## Pre-Application Meeting PRE 24-05

### Follow-up Notes

Mill Creek Meadows 2 Annexation & Subdivision (Schwenke/Vezey property)

Thank you for joining staff for pre-application meeting PRE 24-05 on April 25 to discuss the proposed annexation and subdivision of Tax Lot 051W19B000600 with no street address. The lot is approximately 30.45 acres and within the urban growth boundary (UGB). It is designated Low Density Residential according to the Comprehensive Plan and would be zoned Single-Family Residential (RS) upon annexation. Section references throughout this agenda are to the Woodburn Development Ordinance (WDO).

*TSP Fig. 6 (Local street connectivity)*

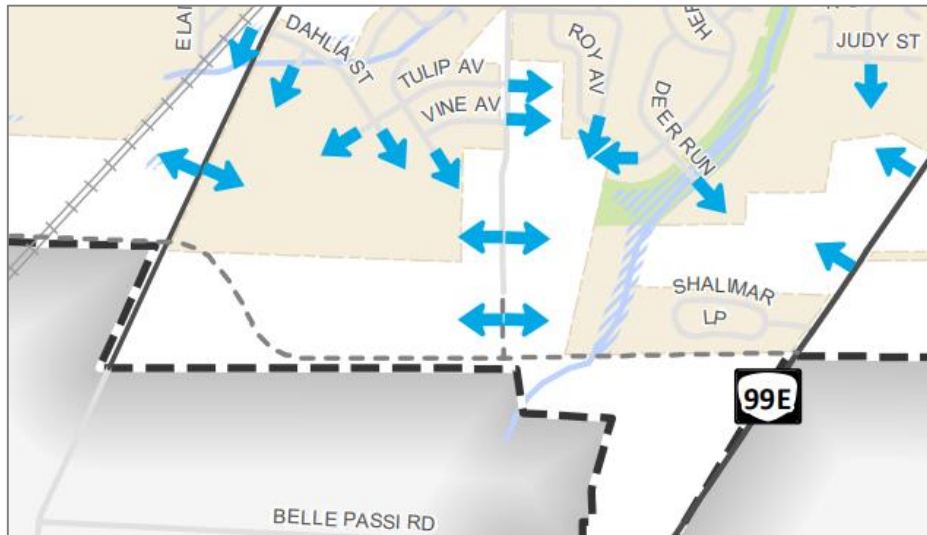
In *TSP Fig. 6*, a blue arrow indicates a local street connection leading to the site’s east boundary with Brown St. (The street in Mill Creek Meadows closest to the blue arrow is Upland Ave, and in Mill Creek Meadows 2 the first east-west local street closest to the site east boundary is the one closest to Brown St and Upland Ave.)

Figure 3.01C – Minor Arterial

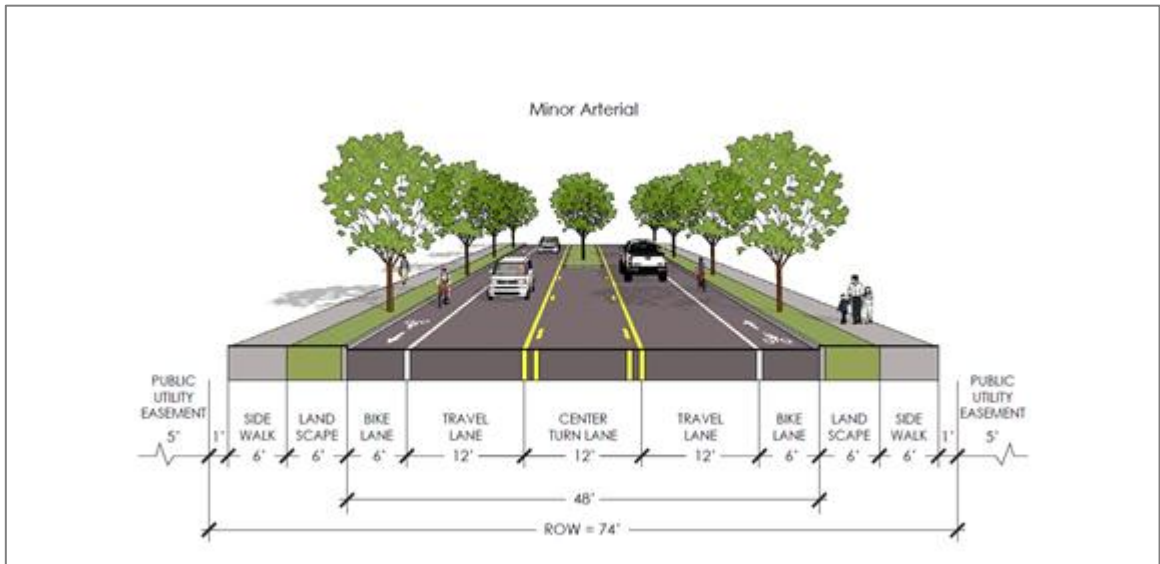
1. ROW: The standard cross section for the South Arterial / E. Traverse Road is WDO Figure 3.01C “Minor Arterial”. (Background: Because of what was negotiated for PUD 22-01 Mill Creek Meadows at 1490 Brown St, [1] alignment will continue west from Mill Creek Meadows as “E. Traverse Rd”, following north side of site [the south side of Boones Crossing], and [2], it is to be constructed as a “Minor Arterial “ road per TSP Project R29 [p. 33] described as “(2 lanes)” and what Mill Creek Meadows is constructing (two-lane road with room for two-way left turn lane.)

- ROW: The standard cross section for S. Boones Ferry Rd is WDO Figure 3.01C “Minor Arterial”. The total required right-of-way (ROW) is 74 ft, 37 ft each side of centerline. Marion County Tax Map 051W19B suggests that the west half of ROW is 30 ft, a deficit of 7 ft that a developer must dedicate. The developer’s surveyor would confirm field conditions and the exact minimum dedication.
- PUE: Same as above.
- Improvements: Same as above.

Figure 3.01G – Local Residential Street with Parking Both Sides, 60 Foot Right-of-Way

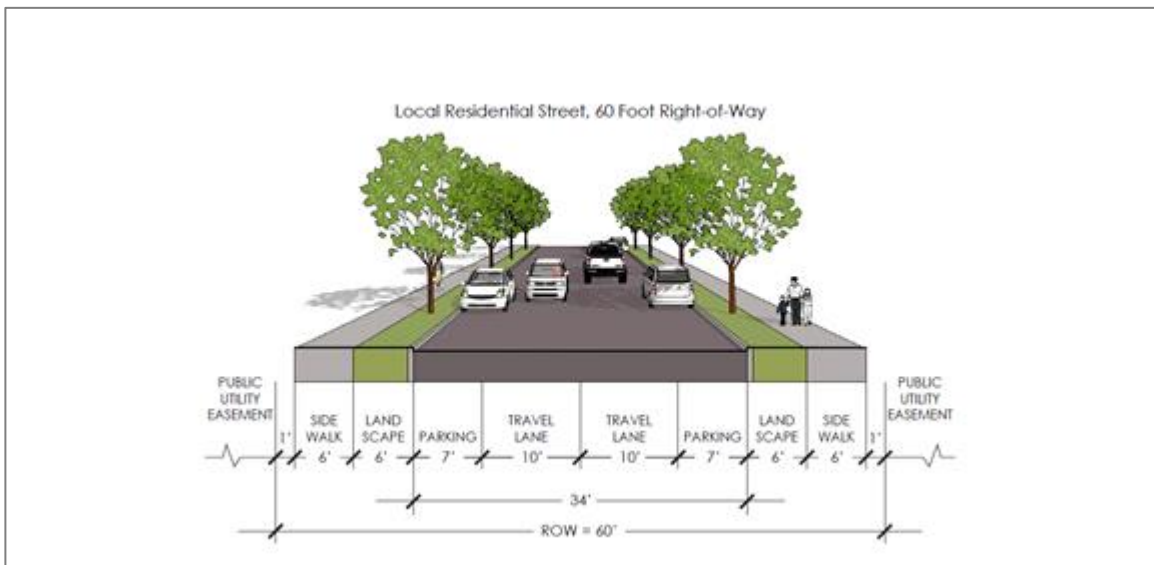
- ROW: Per Figure 3.01G.

- PUE: Same as above.
- Improvements: Per Figures 3.01A & 3.01G.

## Mill Creek Meadows II Development Concept Plan

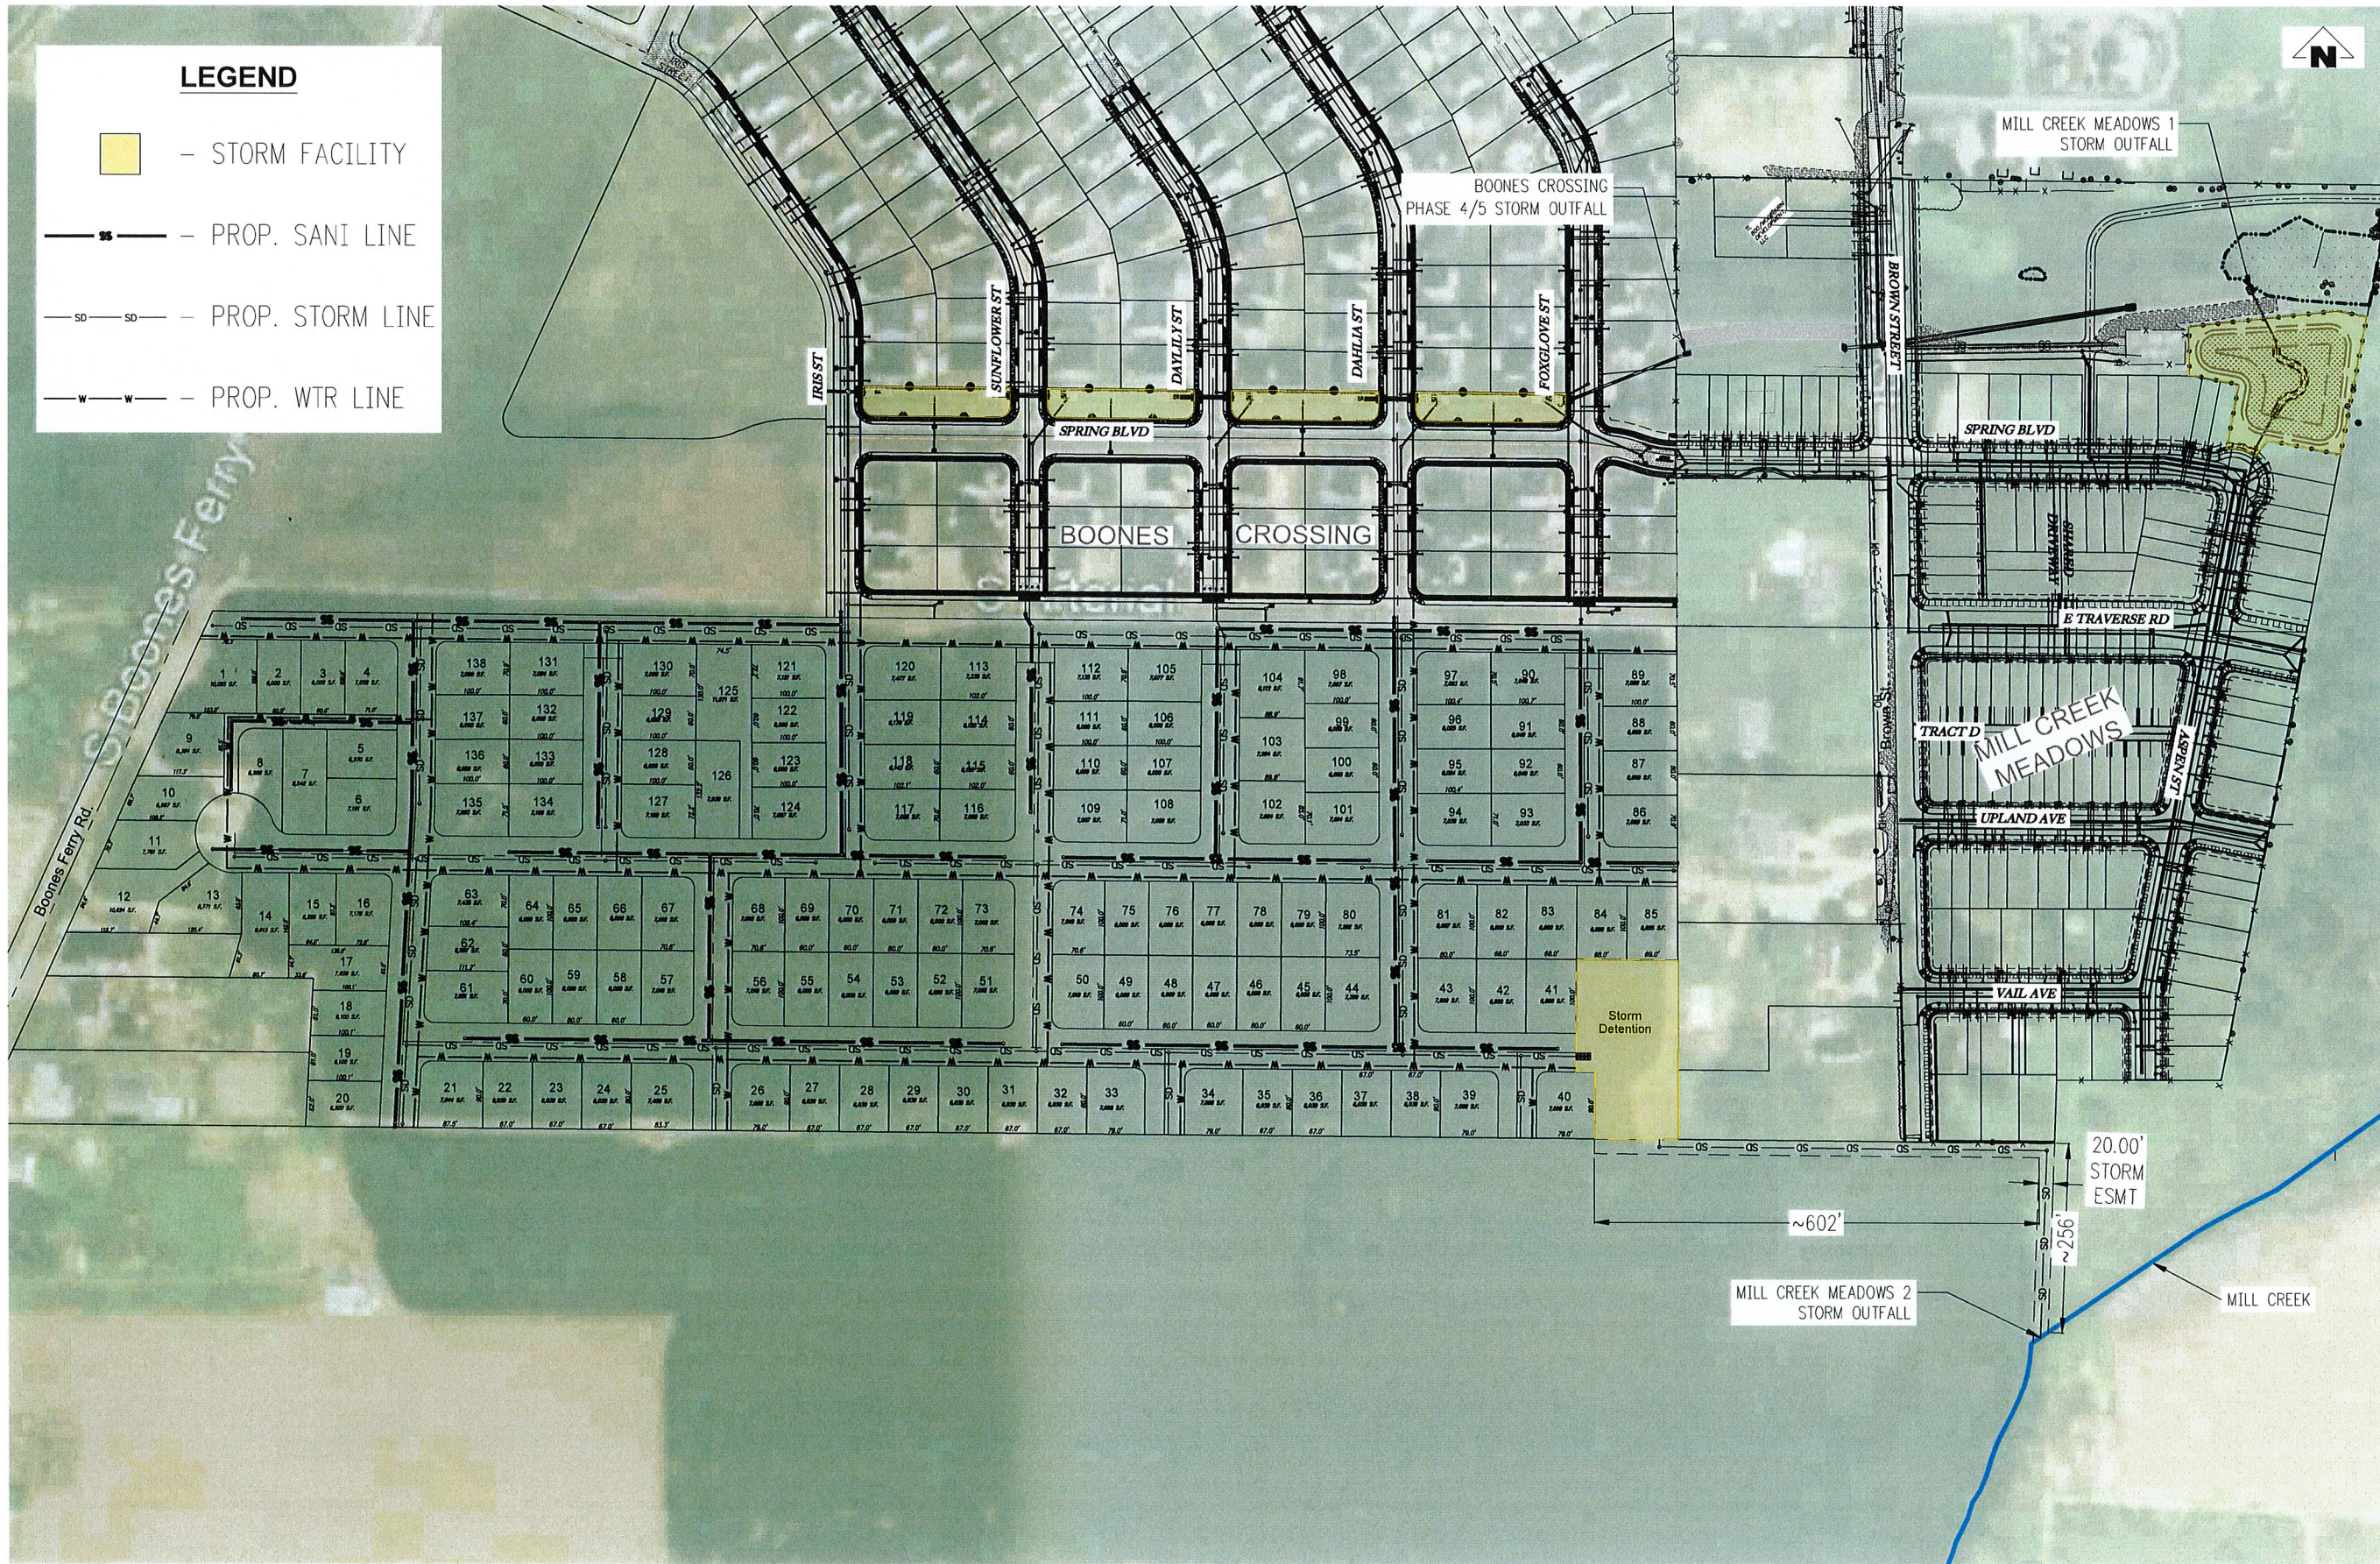
- Extend Iris, Sunflower, and Dahlia Streets straight through to the south property boundary. (This assumes relocation of the east 3 south street stubs.)
- If a licensed engineer stamps a supporting analysis in terms of traffic safety, extend Upland Ave west to S. Boones Ferry Road to provide alternative route to the intersection of Boones Ferry and the South Arterial / E. Traverse Rd. (If no extension, see item d. above, first bullet about an off-street bicycle/pedestrian corridor.)

- Name the east-west streets to be aligned with those in Mill Creek Meadows as Upland and Vail Avenues.
- Name the west north-south street beginning with “C”.
- Resize the stormwater detention pond at the SE corner to be south of the south east-west street to not preclude a street stub to the east property boundary.

1. Align not only the South Arterial / E. Traverse Road but also the proposed local streets with those in Boones Crossing and in Mill Creek Meadow.
2. Iris and Dahlia Street are to continue straight (north-south) along the entire development.

3. Limit street connectivity on the South Arterial / E. Traverse Road between Iris St at the east and S. Boones Ferry Road at the west, specifically, by reducing proposed street intersections from two to one. Comply with stopping sight distance requirements and traffic analysis report.

- a. Current RS zone site development standards are per Table 2.02B.
  - i. Note the definitions for “lot depth, average” and “lot width” in 1.02. A number of the lots do not appear to meet minimum requirements for one or both of these standards (for example lots 2-4, 11, 37, 66, etc).
